REMARKS

Marked Up Copy of Amended Claims

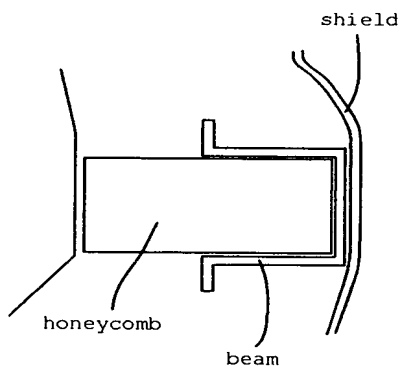
In paragraph 4 of the Office Action, the Examiner rejected claims 1-7 under 35 U.S.C. § 102(b) as being anticipated by Goupy et al.

Claims 1 and a portion of claim 4 have been combined in amended claim 1.

The present invention provides an improved energy absorption device which comprises a honeycomb structure having at the top, a stiff containment element made of a high tensile material such as steel. The containment element is sized to withstand the stress of an impact and the resulting lateral thrust that is generated by the honeycomb structures when they are impacted by a force applied to the beam element.

Prior art

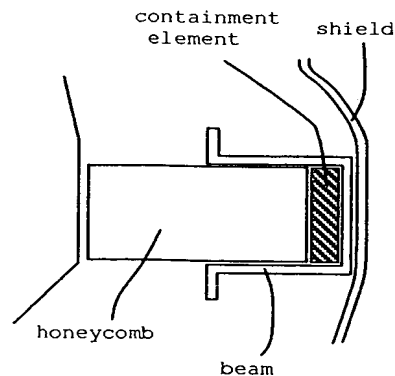
Goupy et al. discloses an energy absorbing beam (1) inserted within a shield (3) and disposed between the energy absorbing elements (2) and the shield (3). Goupy et al. does not disclose the use of a containment element according to the invention. The beam of Goupy et al. merely discloses a structure that disperses the impact forces over the honeycomb support structure. The honeycomb structure of Goupy et al. is not capable of resisting lateral thrusts that develop as the honeycomb absorbs an impact force that is received from the beam element. The containment structure, which is not suggested by Goupy et al., operates to prevent the lateral collapse of the honeycomb. Figs. 3 and 5, of the present application, show the benefits of the containment structure when the honeycomb is impacted with force.

When the beam in the Goupy et al. design is subjected to an impact force, there is no containment element to prevent lateral movement of the honeycomb along the longitudinal axis of the beam. The containment structure of the present invention functions as a "cap" to prevent movement along the longitudinal axis of the beam. The Goupy et al. beam does not provide or disclose any means for providing a containment effect with regard to lateral thrusts that are generated by direct impact on the beam element.

Fig. 2 of Goupy et al. shows the absence of any element which would be capable of restricting lateral movement of the end of a collapsing honeycomb 2, along the longitudinal axis of the beam 1. This is the movement that is prevented by the use of the applicant's containment structure. The Goupy et al.
